# VKM 25215 / VKM 25216

Technical Bulletin - November 2009

OE DESIGN EVOLUTION

OE Idler #: 56 36 395 / 6 36 730 / 6 36 747 / 6 36 928

## VKM 25215 & VKM 25216

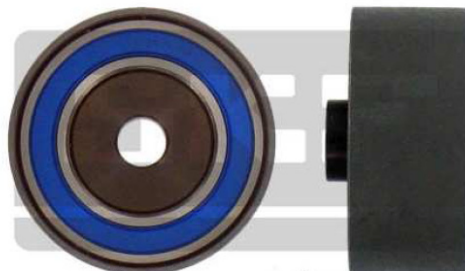
Opel has changed the design of two engine idlers →SKF part numbers:  
VKM 25208 and VKM 25209.

To follow Opel's specifications, SKF has also modified their idler designs:

- VKM 25208 is replaced by VKM 25215
- VKM 25209 is replaced by VKM 25216

The replacement of the fixing bolt is essential - thats why SKF always include the bolt with the idlers concerned (VKM 25215 and VKM 25216).

The new idlers VKM 25215 and VKM 25216 have an improved design with a higher load capacity.

The only difference between kit references VKM 25215 and VKM 25216 is the bolt length - the idlers are identical. This is what differentiates the applications for each of the individual reference!

D=65 W=28,5

Screw length: M12 x 50

D=65 W=28,5

Screw length: M12 x 45
